**ROBERT D. COUSINEAU**  
Consulting Geotechnical Engineer  
5924 Temple City Boulevard  
TEMPLE CITY CA 91780  
626 287 9675 FAX 287 0560

Project No. 04-138

RE Addendum Report to Report of June 21, 2004  
720 South San Rafael Avenue

The following is an addendum to the report of June 21, 2004, as requested for you by Dennis Smith, Architect. The reason for the addendum is to respond to the "Review of Soils Report dated June 21, 2004 by Robert D. Cousineau\_\_\_\_", prepared by Sassan Geosciences, Inc., dated August 23, 2005

SECTION A-A

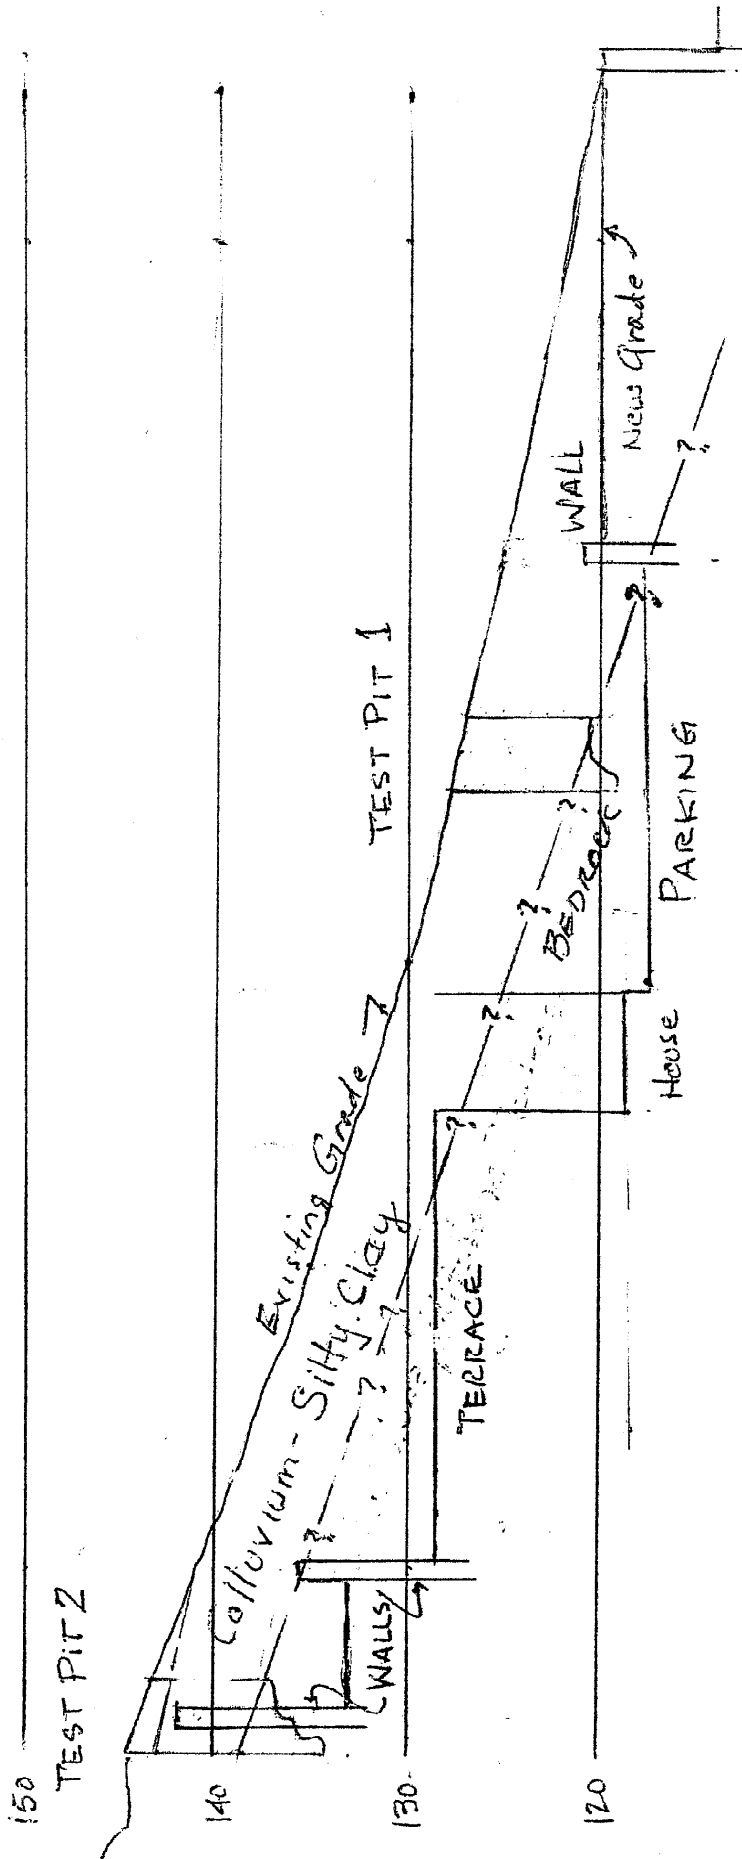
Shoring design is generally a factor addressed when final plans have been prepared. In any case, calculations shown on Plates I and J indicate that the proposed vertical cuts up to 9 feet would be stable. However, to preclude any requirements by governing agencies, it is recommended that cuts over 5 feet in height be sloped back on a 45 degree angle above 5 feet.

# SURFICIAL SLOPE STABILITY

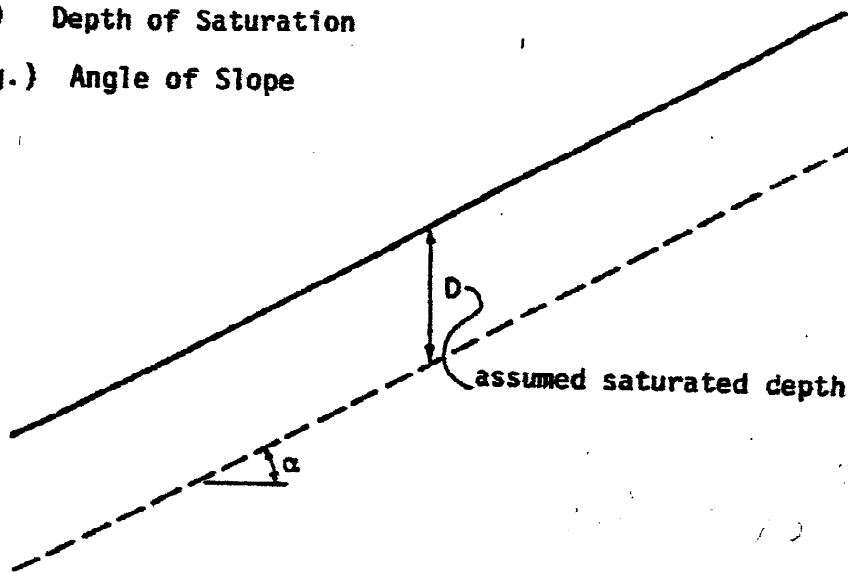
An analysis of surficial stability has been prepared and is shown on Plate H, attached. This indicates a factor of safety of 1.75 which exceeds the generally accepted value of 1.5

$$FS = \frac{C + D \gamma_b \cos^2 \alpha \tan \phi}{D \gamma_{sat} \cos \alpha \sin \alpha} = \frac{100 + 3 \times 56.6 \times 0.94 \times 0.675}{3 \times 119 \times 0.94 \times 0.342} = \frac{100 + 115}{115} = 1.75$$
